**ADDENDUM No. 2**

**PROJECT NAME: District 9 Senior Center – #042920DR**

**DATE: June 8, 2020**

Date: June 4, 2020  
Project: CoSA District 9 Senior Center  
CNG Project No.: 18-0010  
From: CNG Engineering, PLLC  
1917 N New Braunfels Ave. Ste. 201  
San Antonio, Texas 78208

1 MECHANICAL FLOOR PLAN - LEVEL 1  
1/8" = 1'-0"

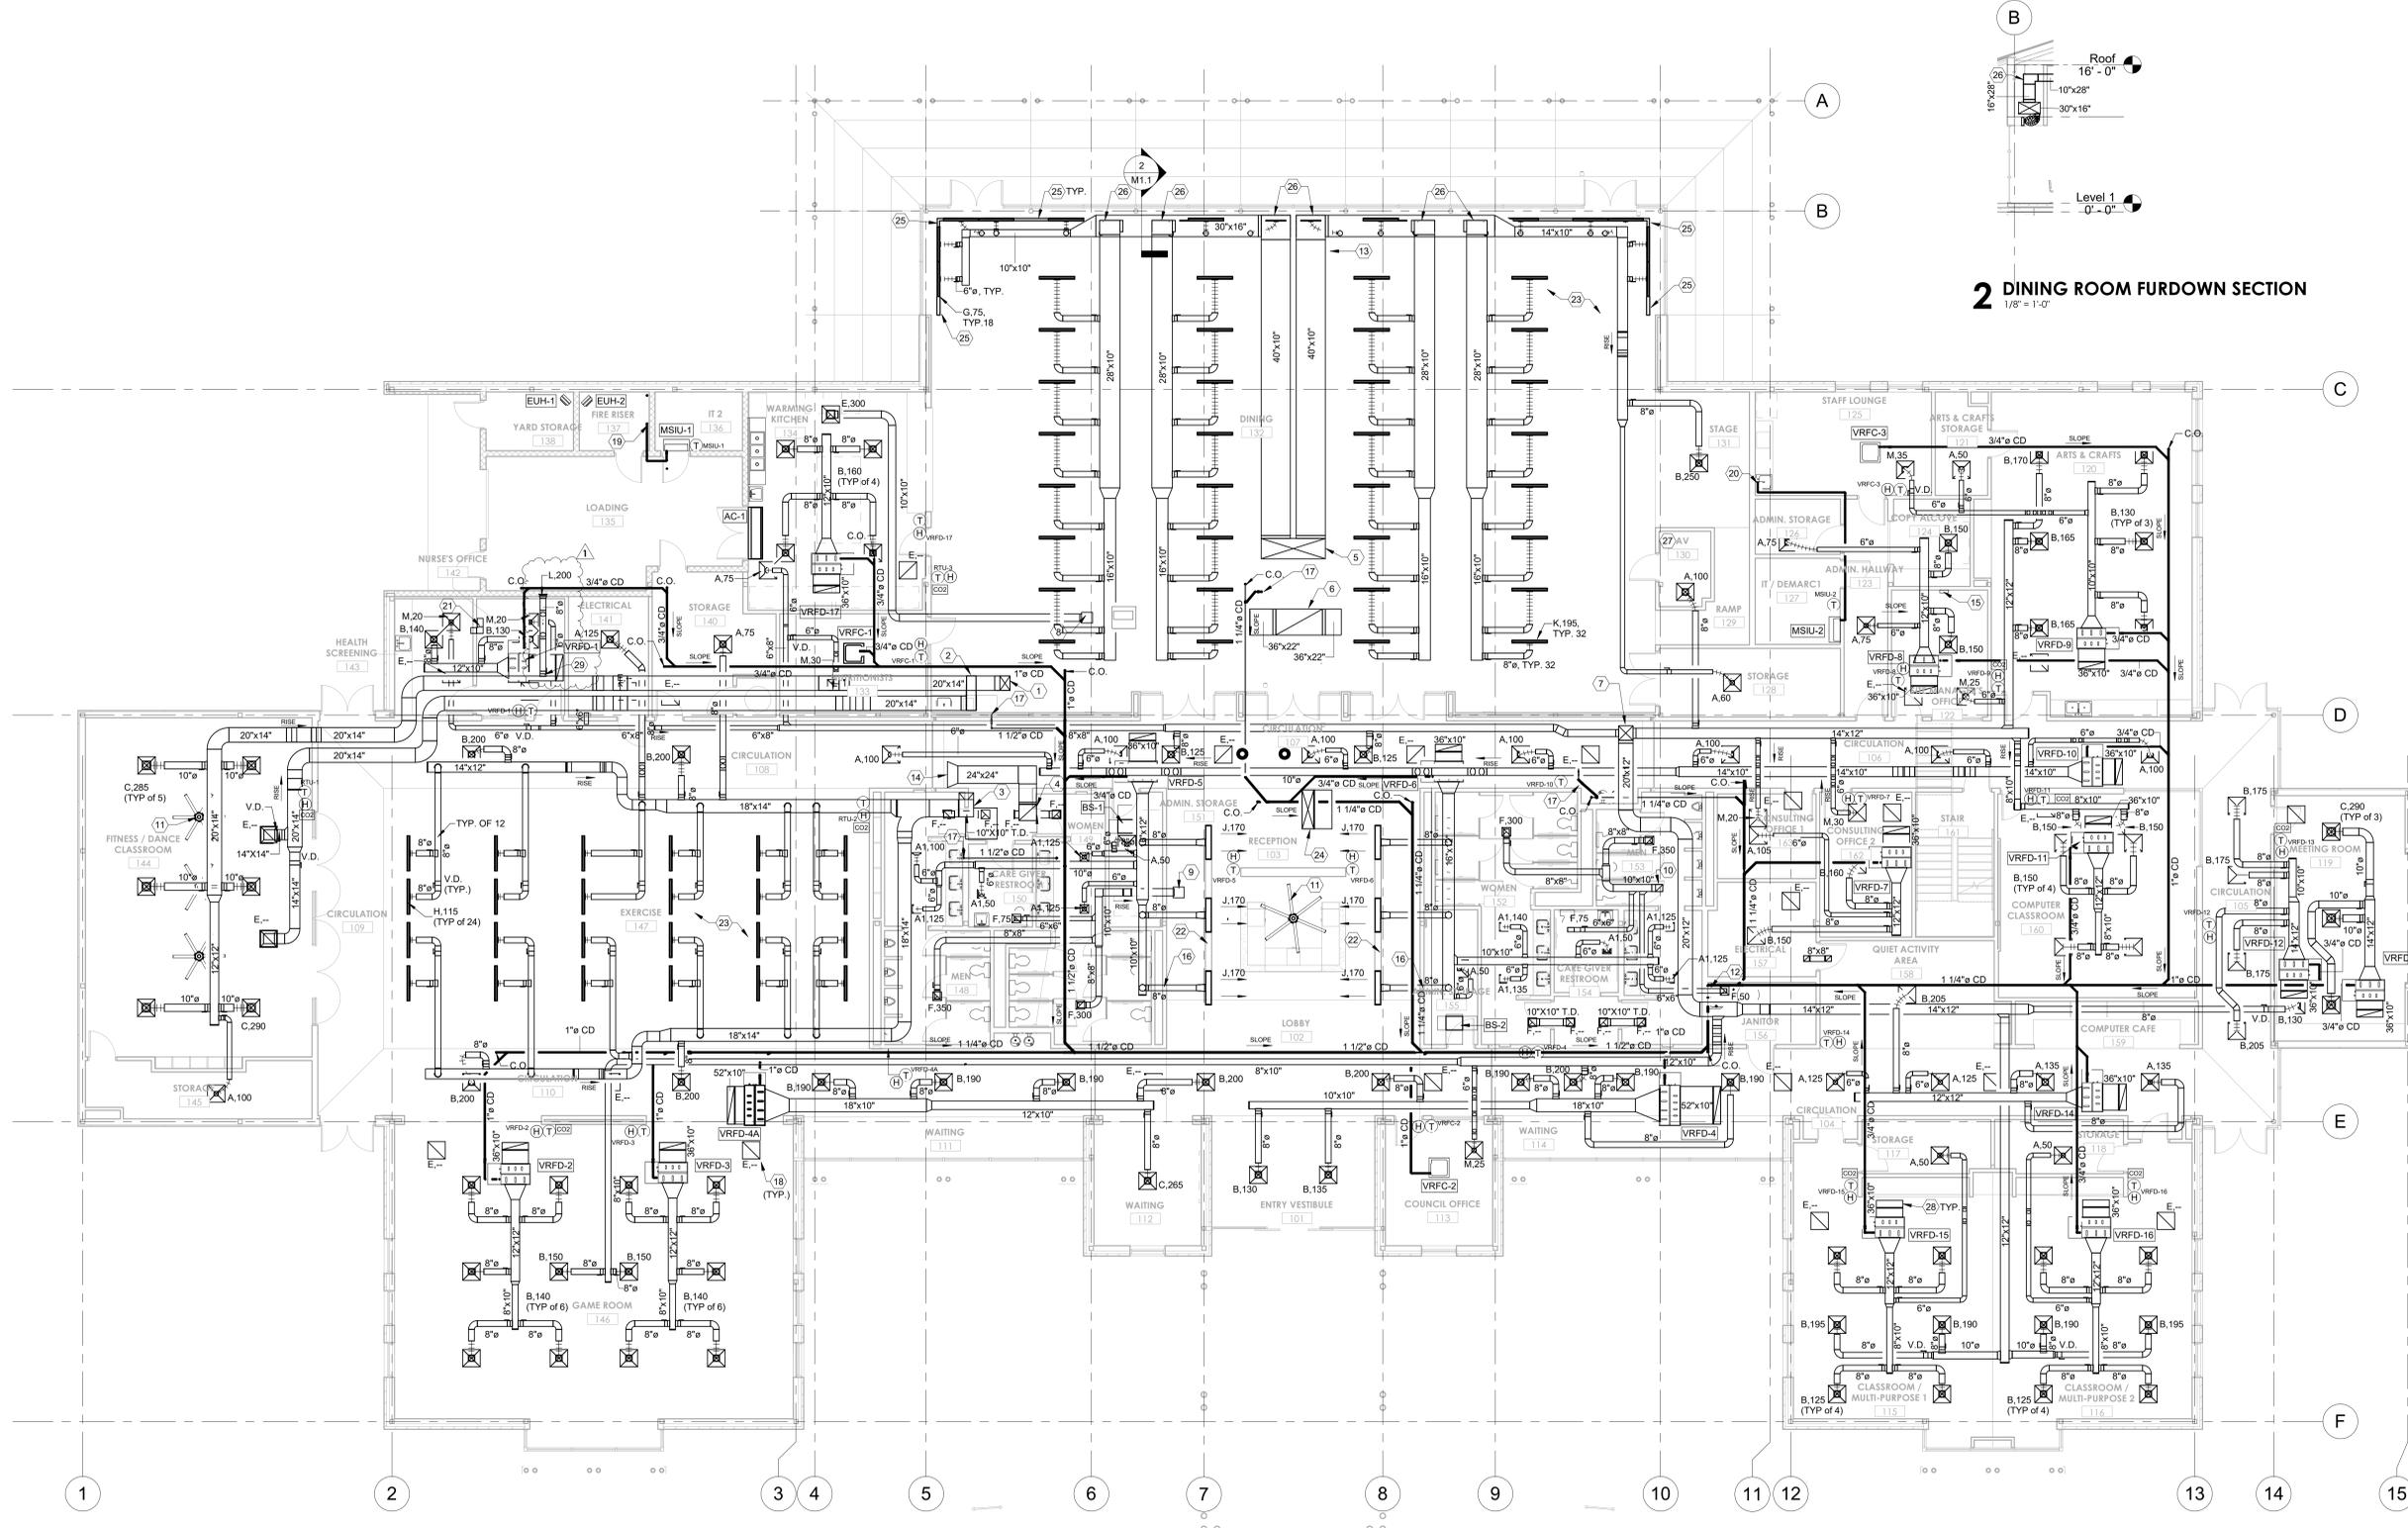
#### REPLACE DRAWING SHEET: M1.1 MECHANICAL FLOOR PLAN – LEVEL 1

Item 1: Revised duct serving Loading 135 to be fed from RTU-1 instead of VRFD-1.

project number 1768  
date 04/21/20  
sheet description MECHANICAL SCHEDULES

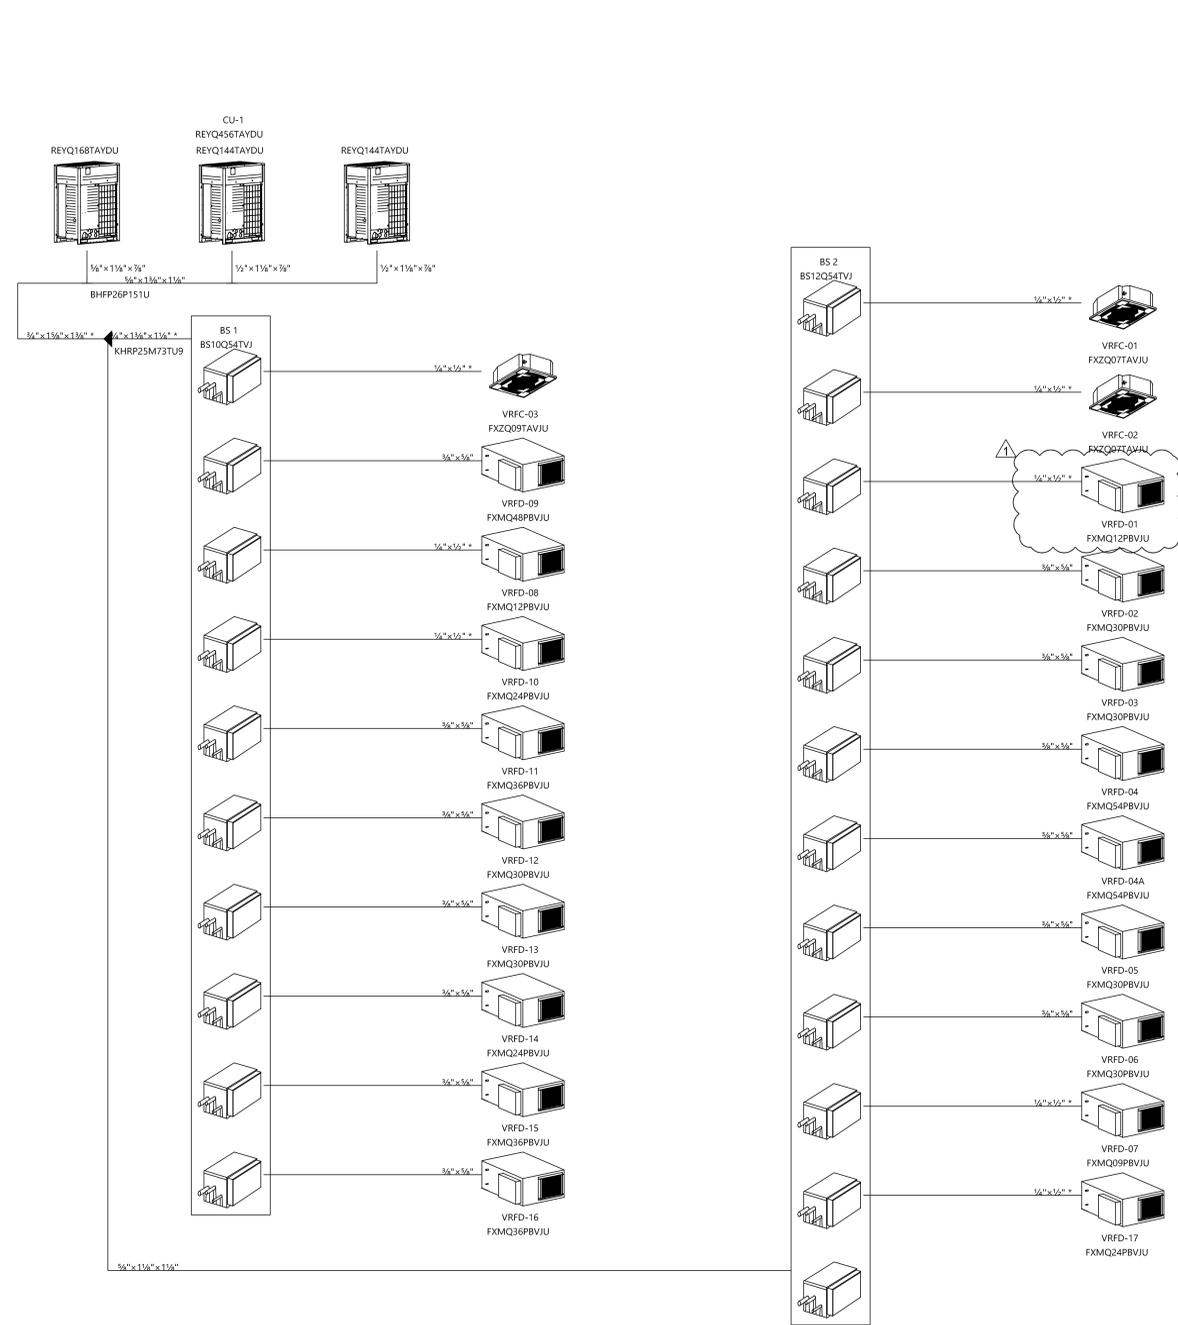
#### REPLACE DRAWING SHEET: M4.1 MECHANICAL SCHEDULES

- Item 1: Revised DX Rooftop Unit Schedule.
- Item 2: Revised VRV Heat Recovery Schedule.

project number 1768  
date 04/21/20  
sheet description MECHANICAL VRV RISER DIAGRAM  
sheet number M5.1

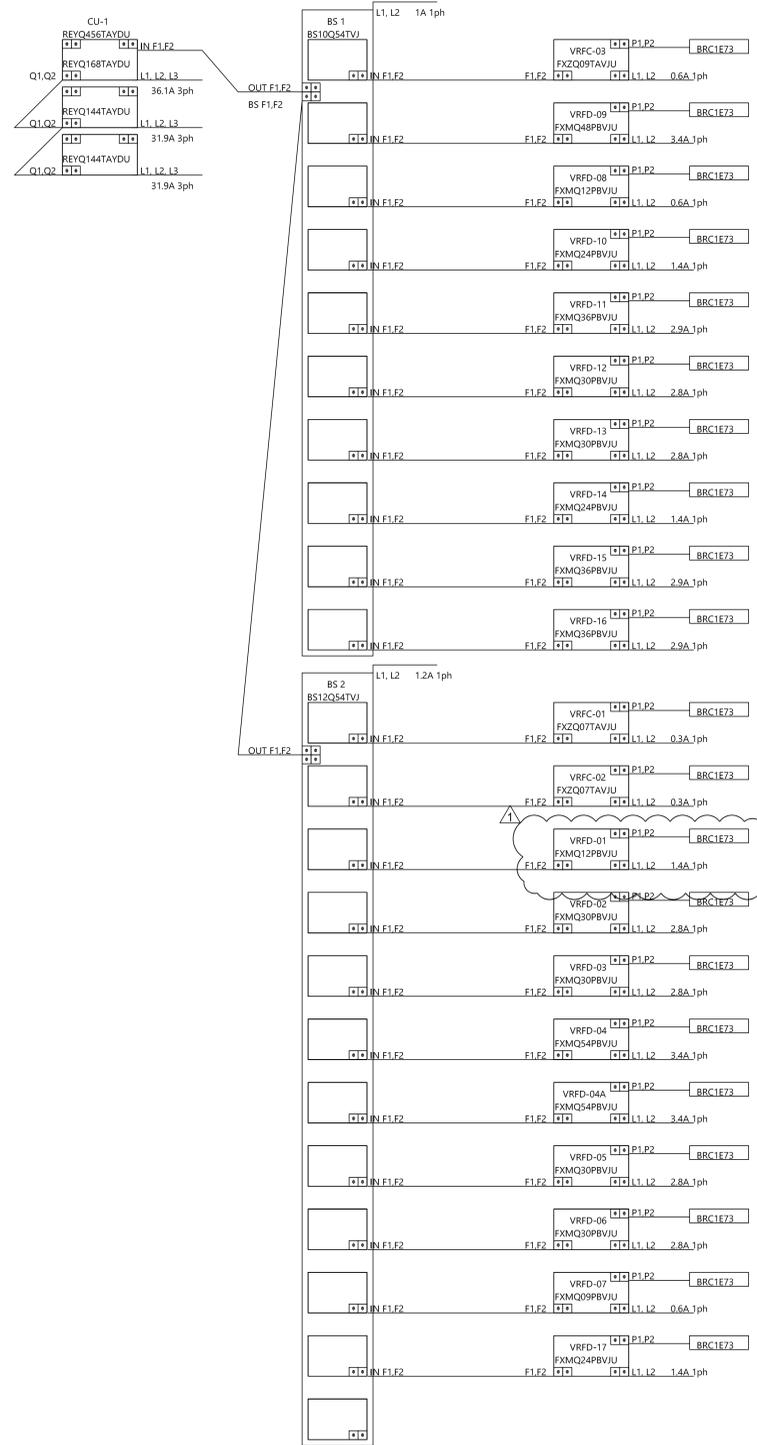
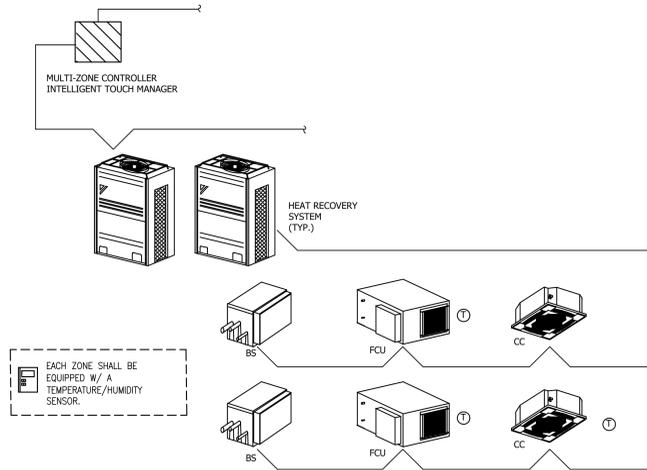
#### REPLACE DRAWING SHEET: M5.1 MECHANICAL VRV RISER DIAGRAM

Item 1: Revised VRFD-1 model number in pipe and wiring riser diagrams.

**4 SINGLE ZONE VAV ROOF TOP UNITS 1,2&3**  
M6.1 NOT TO SCALE

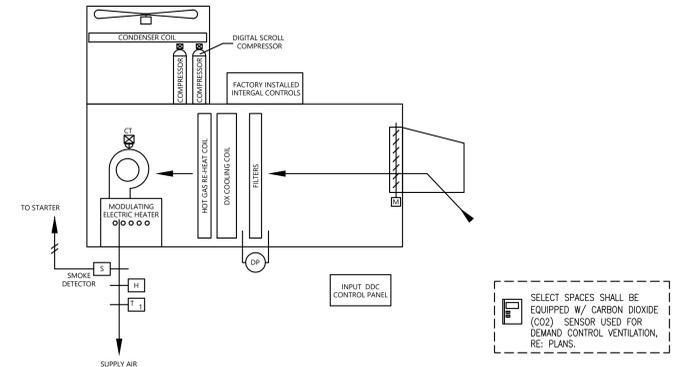
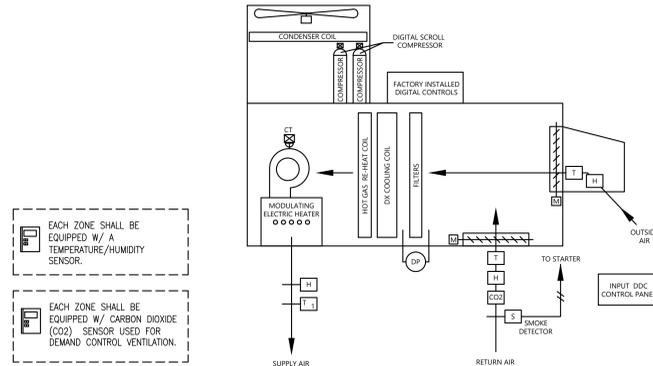
#### REPLACE DRAWING SHEET: M6.1 MECHANICAL CONTROLS

Item 1: Revised controls sequence for SZVAV RTUs.
